**NSW Planning Assessment Commission Determination
Old Clare Hotel Block 3A Central Park Modification
(MP 11_0089 MOD 3)**

27 November 2017

NSW Planning Assessment Commission Determination Report
Old Clare Hotel, Block 3A, Central Park MP 11_0089 MOD 3

Figure 1: Long Section/East Elevation

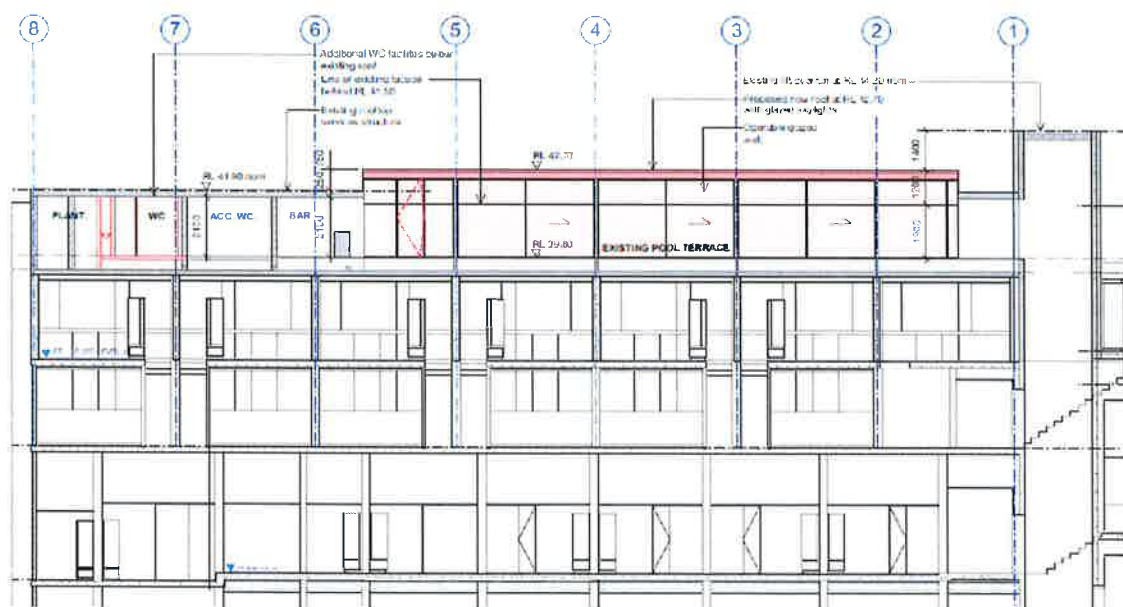
During the site visit, the proponent outlined how the proposed rooftop structure would be constructed along the western edge of the building façade and explained that the structure would be fully enclosed but would contain sliding doors, as shown in the Plans for Approval (see Figure 1). The proponent volunteered that it would be willing to ensure, by way of condition, that between the hours of 8pm and 10pm, the doors could be closed to avoid potential noise impacts on residents of One Central Park. The Commission sought clarification from the Department, confirming that while the doors are shown on the plans for approval, the Acoustic Assessment states: *'It is necessary to consider the detailing of the junctions to ensure all gaps are sealed airtight so that the acoustic performance of the rooftop canopy is not compromised through sound flanking or leaking through the construction'*.

The Commission considers that the requirement for a noise audit within 3 months of operation will allow issues to be identified and enable any occurring impacts to be rectified. The Commission does not support the opening of the sliding doors and has therefore recommended Condition B23(c) to require the western elevation be constructed with no openings.

Based on the recommendations in the Acoustic Assessment, the Commission finds that in order to effectively manage noise impacts, while the rooftop terrace pool and bar is in operation, the sliding doors would need to remain closed. Retaining the doors in a closed position, would prevent noise impacting on neighbouring residents, which is consistent with the assessment submitted by the proponent in its original application and assessed by the Department. The Commission finds the proposal to require the sliding doors be closed when the venue exceeds 30 patrons, has a number of shortcomings including the fact that it would be difficult to manage from a compliance perspective. Condition B23 stipulates the requirements for the rooftop structure, including that it be amended in accordance with the recommendations of the Acoustic Assessment prepared by Parsons Brinckerhoff, dated 22 September 2016.

1 PHOTOMONTAGE OF PRIVACY FILM STUDY
1:100

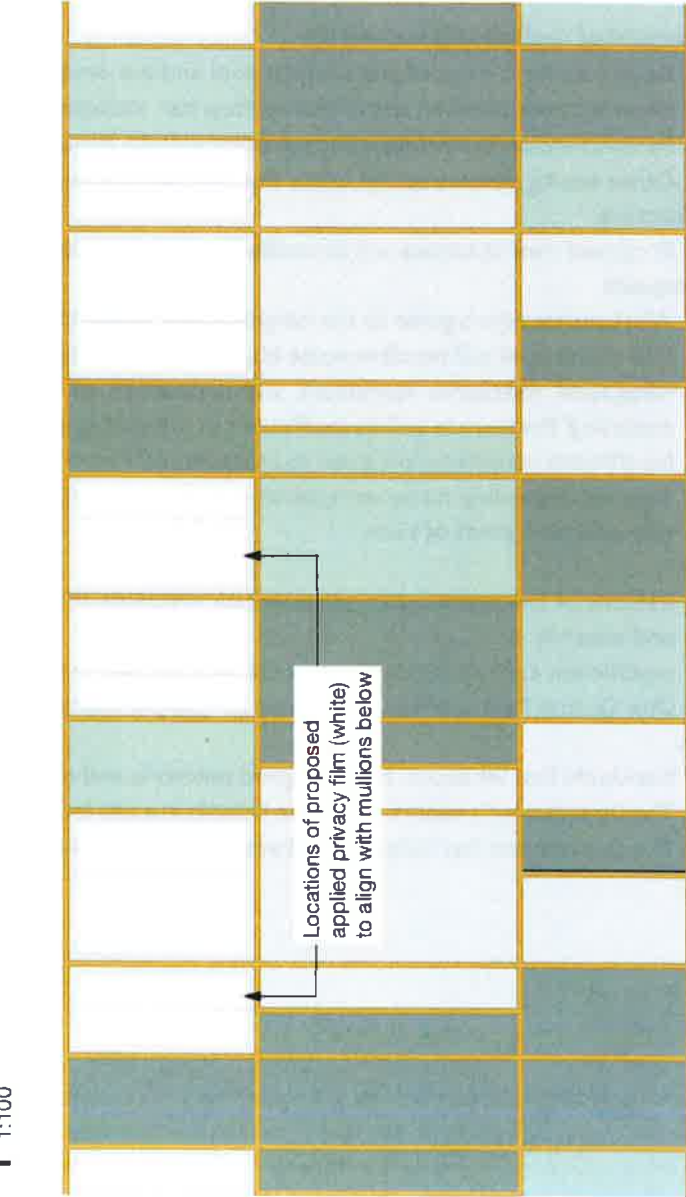
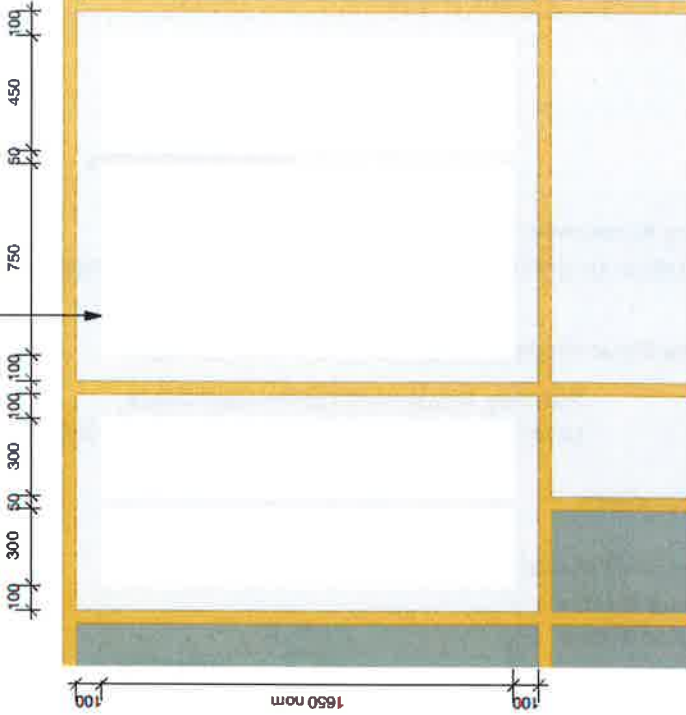
The Department, subsequent to the recommended design and conditional changes, found that the amendments identified by the proponent would sufficiently address privacy concerns. To prevent overlooking, the Department recommended a condition requiring obscured glazing be installed along the western elevation of the roof structure. During the site visit, the proponent presented an alternative treatment for the western façade to address privacy concerns. The treatment involves applying translucent privacy film to the western glazed elevation, in order to obscure views from the rooftop in accordance with the Privacy Film Study (Drawing SK04).

The proponent wrote to the Commission on 20 November 2017 formally submitting the alternative treatment privacy treatment for the Commission's consideration. The proponent also requested various amendments to Condition B23. The Commission sought advice from the Department and determined to retain both the requirement for the roof structure to increase transparency on the western side of the roof by 40% and the requirement for a gloss finish to the soffit cladding, as these measures were proposed by the proponent to address concerns raised by Council. The Commission supports the proposed translucent privacy film on the western façade as it will provide additional privacy to residents of One Central Park. The conditions have been amended accordingly and the plan showing the privacy film study included in the table of plans (Condition A2). The updated plan is provided in Appendix 4.

The Commission finds that the proponent's proposed translucent privacy screen on the western façade will provide additional privacy to residents of One Central Park. The conditions have been updated to reflect this amendment. Further, the Commission considers that any visual and urban design impacts would be very minimal and have been addressed as far as practicable through the proponent's amendments.
